Re: Breezy Pointe Addition
Floodway Fill and Floodway Fringe Fill
for Residential Development
Calfskin Creek
Sedgwick County
WSN: LSG-0077, Notice No. 92523

Subject: Breezy Pointe INDEX #761478

RE: CASE NO. 93-070020P
BREEZY POINTE ADDITION
Wichita, KS

CASE NUMBER: S/D 92-8 - BREEZY POINTE (BAYSIDE ESTATES) ADDITION

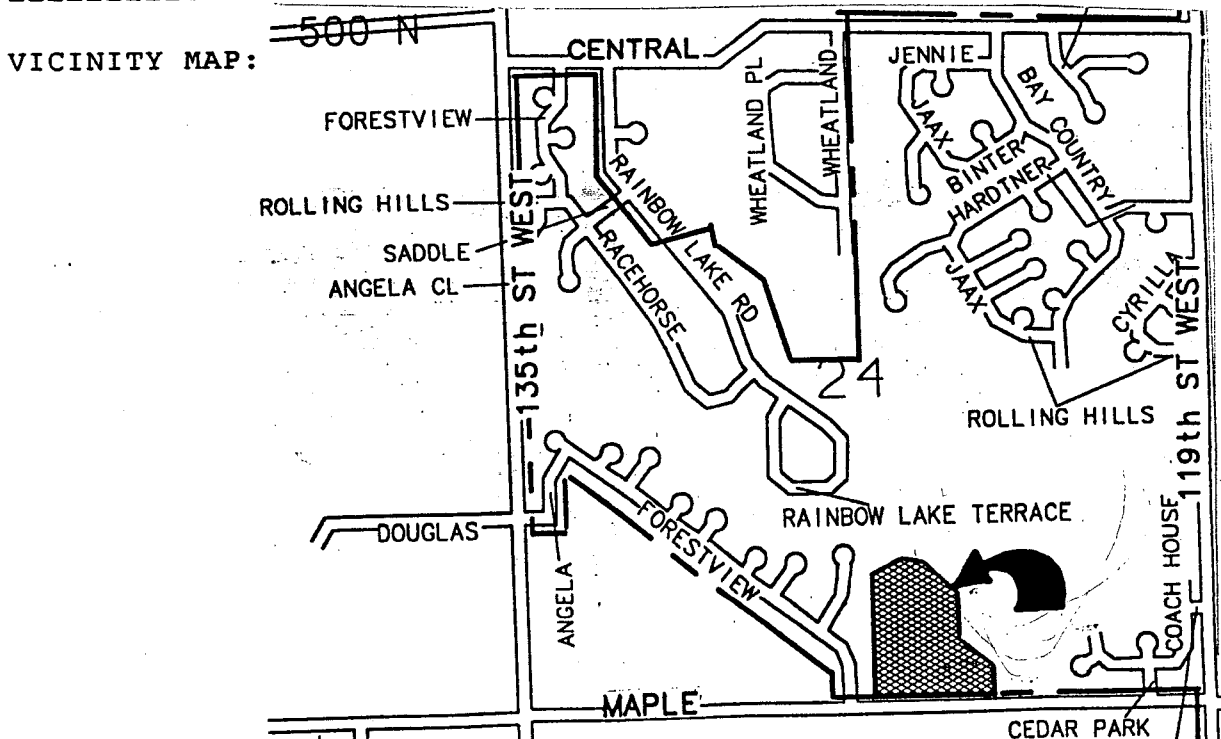
STAFF COMMENTS:

- A. The applicant shall guarantee the extension of City water to serve the lots being platted.
- B. The applicant shall guarantee the extension of sanitary sewer to serve the lots being platted.

- C. The applicant shall guarantee any drainage improvements required by the platting of this property.
- D. The applicant shall guarantee construction of the storm sewers required by this plat.

- E. The applicant shall guarantee the paving of the proposed interior streets.
- F. According to the sidewalk ordinance, a cul-de-sac street connecting to an arterial and serving at least 48 lots is required to provide sidewalk along one side of the street. This plat is only indicating 43 lots plus several Reserves with access to the cul-de-sac. Consequently, sidewalk is not a requirement but the applicant is, however, encouraged to consider including a sidewalk along the east side of Bayside Circle or within any Reserve needed along the east line of this plat. If the applicant requests, these improvements may be included in the paving guarantees.

- H. Based upon a companion plat (Bay Country Estates 2nd) immediately to the east of this site, a gap of unplatted property between the two additions was apparently being created. Preliminary information indicates this plat should be responsible for that property and consequently any such property needed to be included within this addition's perimeter. This final plat now appears to include any such property within its perimeter. The applicant's agent needs to verify this.

- S. The representative from the City Engineer's office should be prepared to comment on the status of the applicant's drainage plan. Specifically, is the minimum building pad correct, are the boundaries of the floodway adequate and are any drainage guarantees required with the platting of this property? Engineering also needs to indicate the acceptability of the floodway easement being used rather than the more typical case of platting a Reserve, for drainage (floodway) purposes.

CASE NUMBER: S/D 92-8 - BAYSIDE ESTATES ADDITION

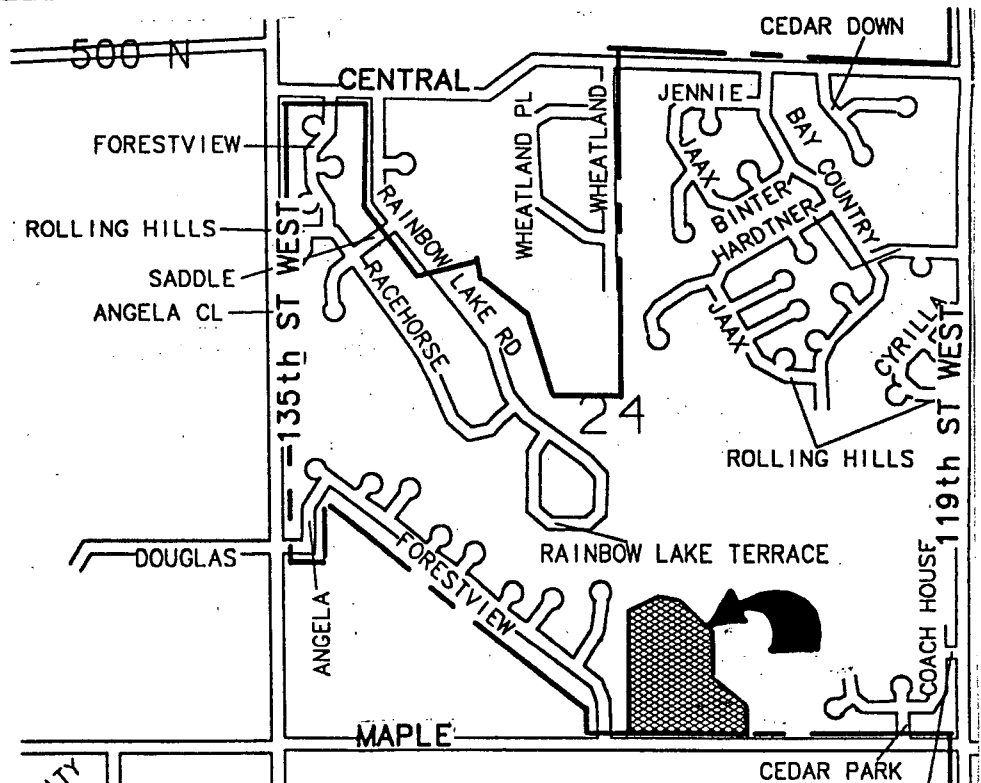
- E. The applicant shall guarantee the paving of the proposed interior streets.
- F. According to the sidewalk ordinance, a cul-de-sac street connecting to an arterial and serving at least 48 lots is required to provide sidewalk along one side of the street. This plat is only indicating 43 lots plus several Reserves with access to the cul-de-sac. Consequently, sidewalk is not a requirement but the applicant is, however, encouraged to consider including a sidewalk along the east side of Bayside Circle or within any Reserve needed along the east line of this plat.

- I. Since significant Reserve or open space area is planned also to the north of this site, if this plat is to share in the use of such areas it is recommended that some form of access to such areas be provided in the vicinity of lots 28 to 31. Either a portion of Reserve or an access easement should be considered from the end of the cul-de-sac into the open space area to the north.

- J. The final plat shall state in the plattor's text the purposes of the proposed reserves as well as who is to own and maintain the reserves.
- K. Provisions shall be made for ownership and maintenance of the proposed reserves. The applicant shall either form a lot owners' association prior to recording the plat or shall submit a covenant stating when the association will be formed, when the reserves will be deeded to the association and who is to own and maintain the reserves prior to the association taking over those responsibilities. This covenant shall also provide for the maintenance of the "parking strip" located along the south line of this plat and the paved surface for Maple.

- N. Requirements for a final plat (see pages 24-29, Part 4, Article 5 of the MAPC Subdivision Regulations).
- O. Prior to or at the time of submitting the final plat, the applicant shall submit a drainage plan to City Engineering for review and approval.
